SWITCHOVER DOCUMENT

ZK2-A Series
Multistage ejector

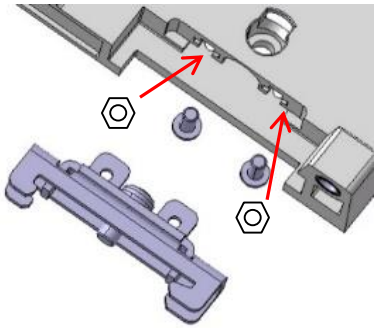
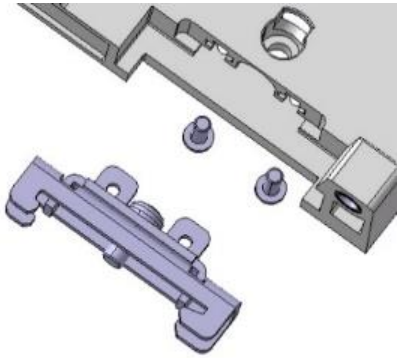
1- Change to convex clip for mounting pressure sensor/switch

Female thread added to bracket, where no nut is needed

Clip part number:
ZK2-CL3-2-A

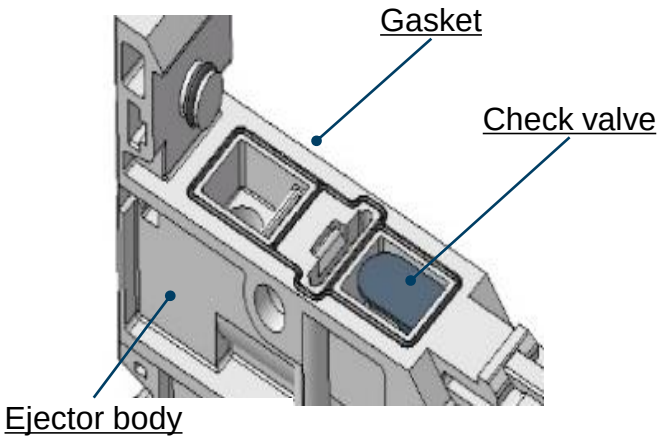
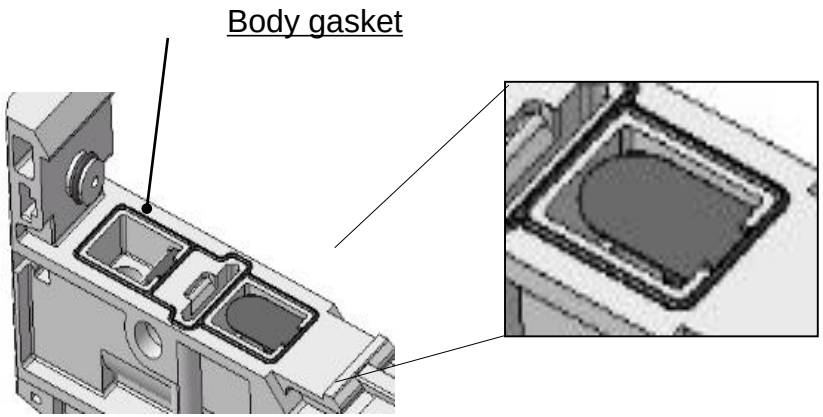
- Integration of check valve into body gasket

Separate gasket and check valve

Integrated check valve and gasket

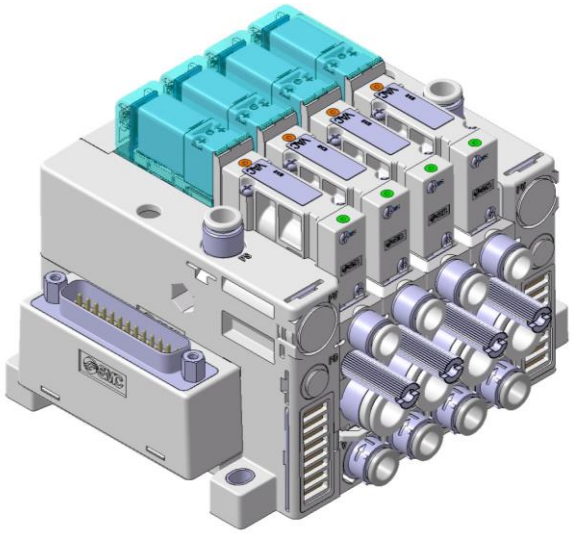
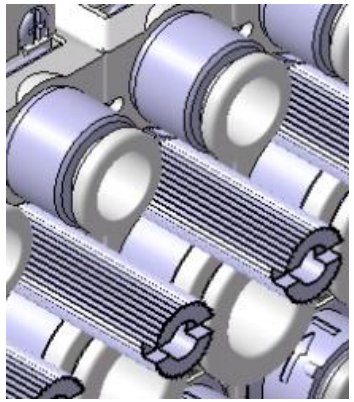
- Long lock nut available as standard
- 18mm longer lock nut.

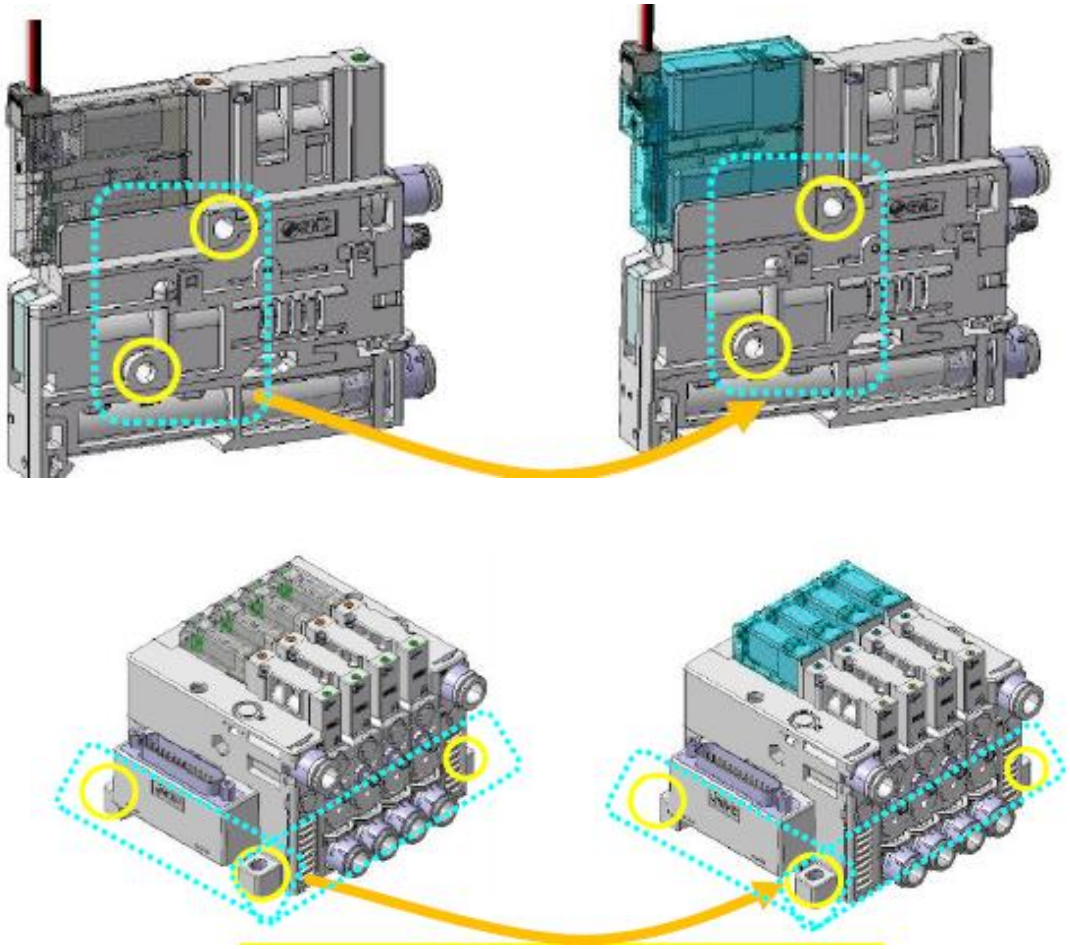
- Mounting is interchangeable with the current model
- Both single ejector unit and manifold have the same mounting hole pitches and port sizes.
- New top mounting holes, making mounting of the ejector easier than the existing product.

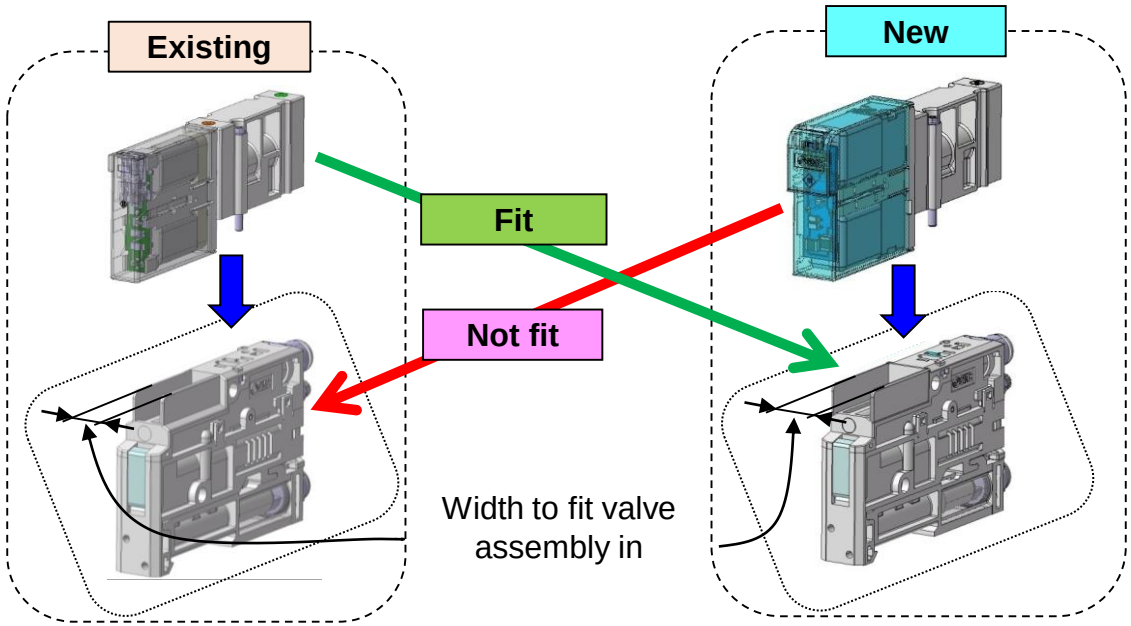
- New valve assembly does not fit into existing/single unit ejector.
- As new V100 pilot valve is wider than previous S070 pilot valve:

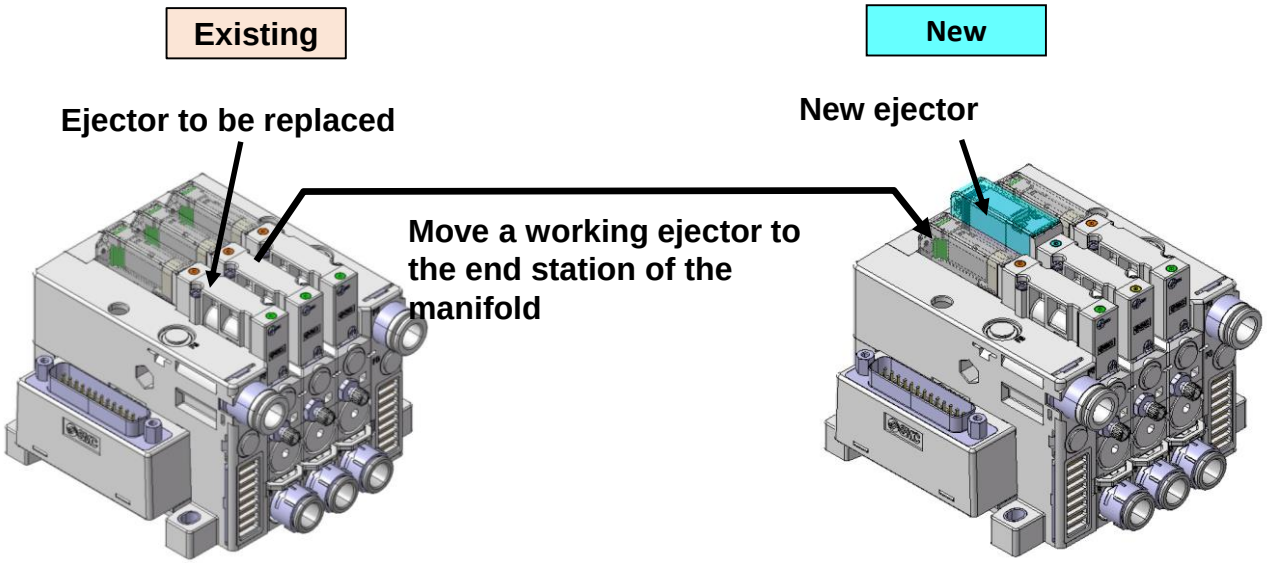
- New valve fits in middle stations of the existing manifold

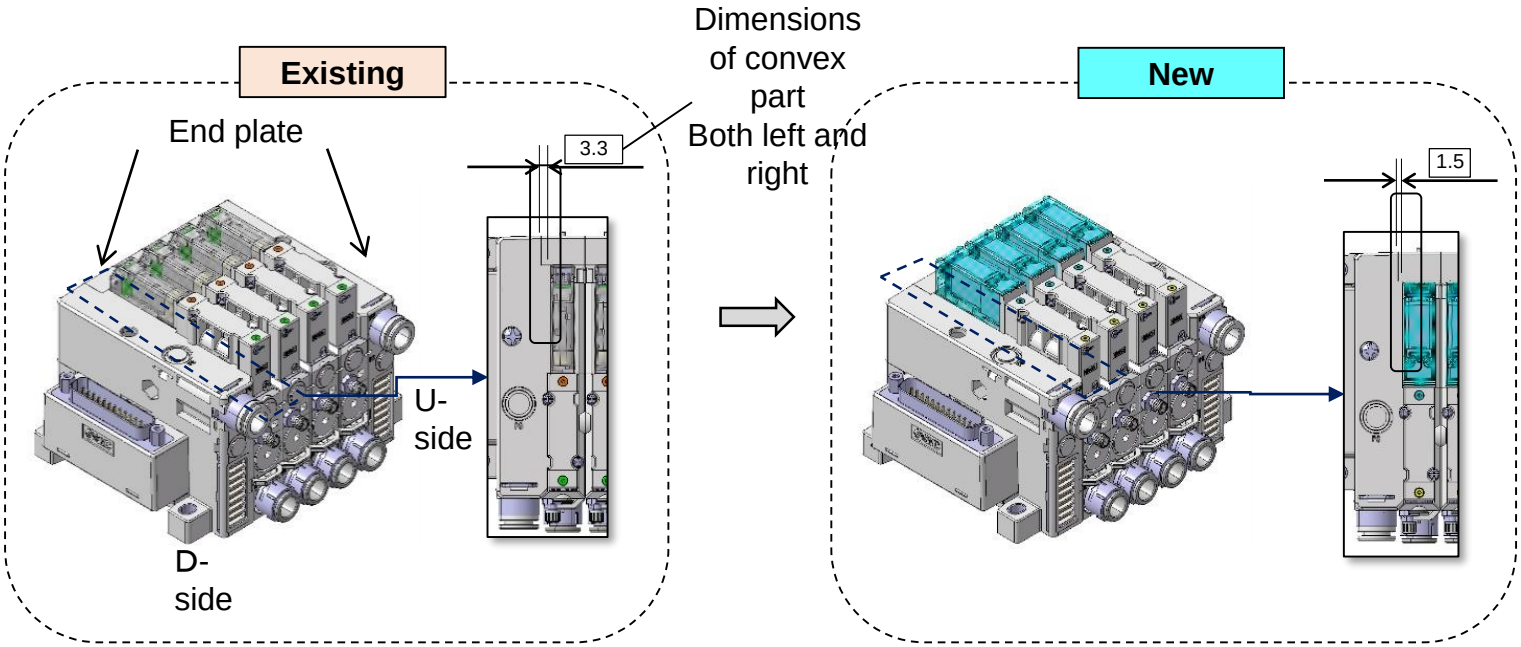
- New valve does not fit into the first and last stations of existing manifold

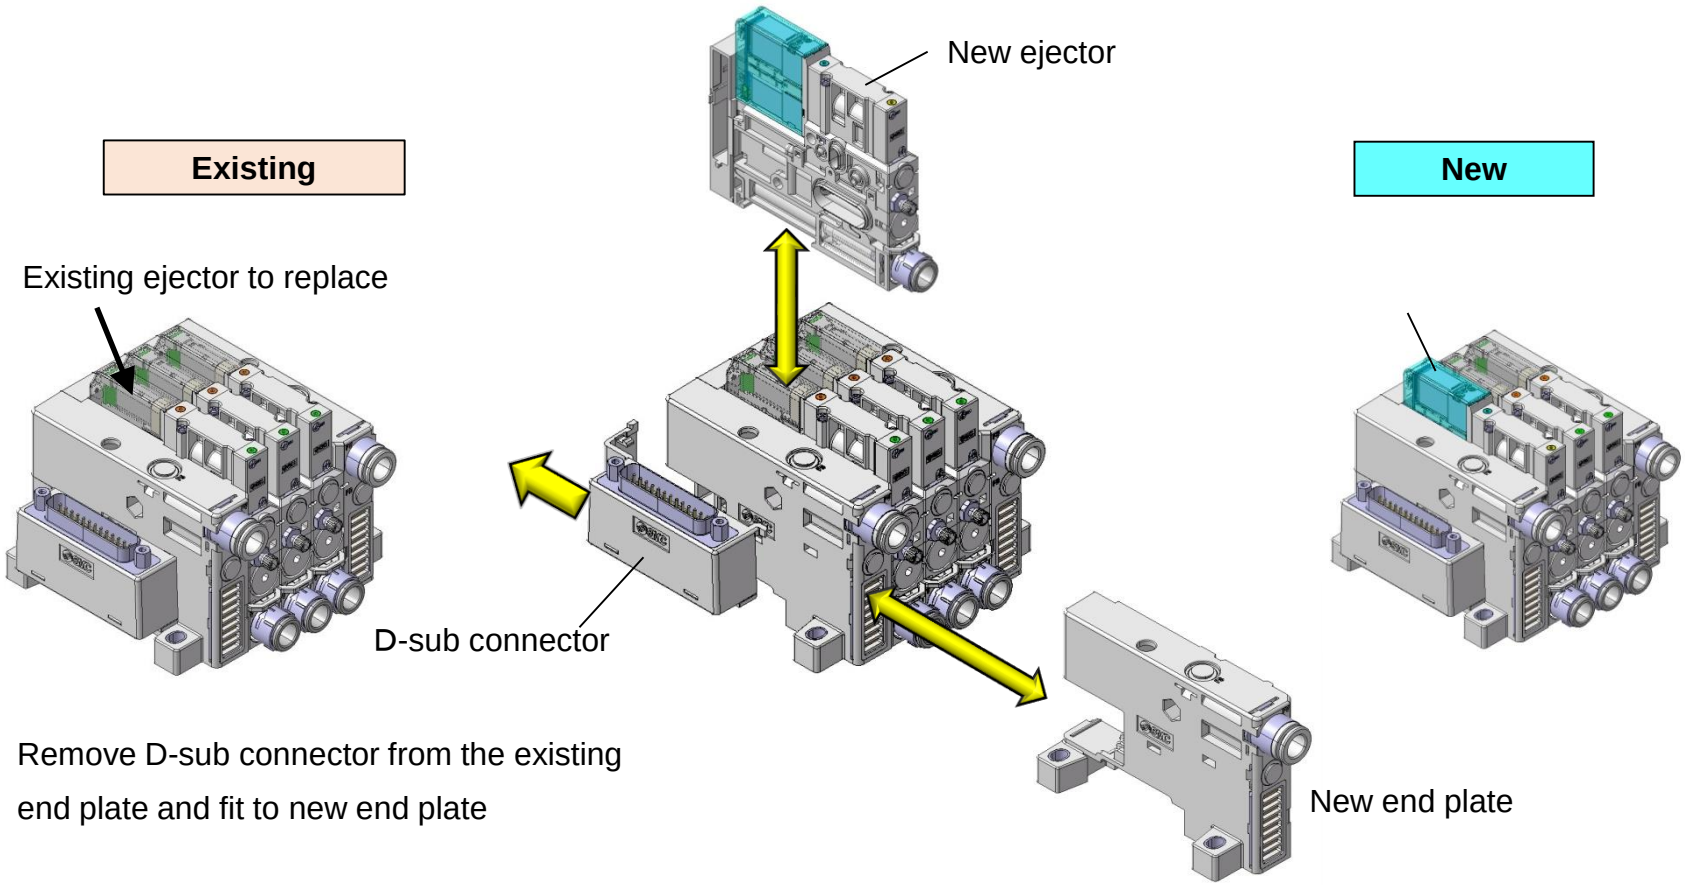
- End plate must be replaced to mount new ejector in the first or last station of the existing manifold

Remove D-sub connector from the existing end plate and fit to new end plate
